# Access Compliance Report

## Public Rights-of-Way

Intersection ID: 49314	Main Street: WESLEY_ALAN_LN	Cross Street: ROCKLAND_DR	Location: NW
ADA ID: 5EBE55B52B14	Ramp Type: Perp	Initial Pass/Fail: Fail	Overall Compliance: No
Severity Score: 10			
Codes/Mitigation Info/Possible Solution		Field Measurements/Component Compliance

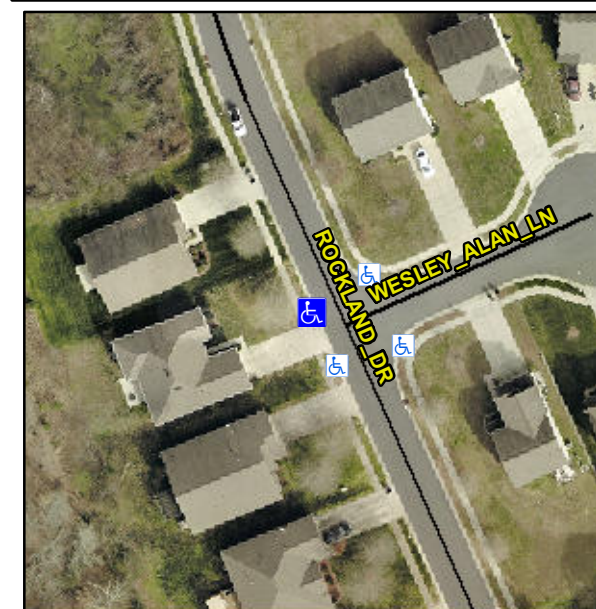
**Not Found, R304.5.1**

Compliance	Description	Data	Compliance	Description	Data
N/A	Ramp Length (in)	48.0	Yes	Ramp Slope (%)	5.7
No	Ramp Width (in)	47.5	Yes	Ramp XSlope (%)	4.3
N/A	Flare Type LT	N/A	N/A	Flare Type RT	N/A
N/A	Flare Slope LT (%)	N/A	N/A	Flare Slope RT (%)	N/A
N/A	Flare Traversable LT?	N/A	N/A	Flare Traversable RT?	N/A
N/A	Landing Length (in)	N/A	N/A	DWS Provided?	N/A
N/A	Landing Width (in)	N/A	N/A	DWS Contrast?	N/A
N/A	Landing Slope (%)	N/A	N/A	DWS Length (in)	N/A
N/A	Landing X Slope (%)	N/A	N/A	DWS Full Width?	N/A
N/A	Landing Curb? (Y/N)	N/A	N/A	DWS Offset (in)	N/A
N/A	Shared Landing?	N/A			
N/A	Gutter Ponding?	N/A	N/A	Gutter Slope (%)	N/A
N/A	Gutter Lip Ht (in)	N/A	N/A	Gutter X Slope (%)	N/A
N/A	Painted X Walk1?	No	N/A	Painted X Walk2?	N/A
	X Walk 1 Direction	To NE		X Walk 2 Direction	N/A
N/A	X Walk 1 Width (in)	N/A	N/A	X Walk 2 Width (in)	N/A
	X Walk 1 Slope (%)	4.0		X Walk 2 Slope (%)	N/A
	X Walk 1 X Slope (%)	5.0		X Walk 2 X Slope (%)	N/A

**Remove & Replace Entire Ramp.**
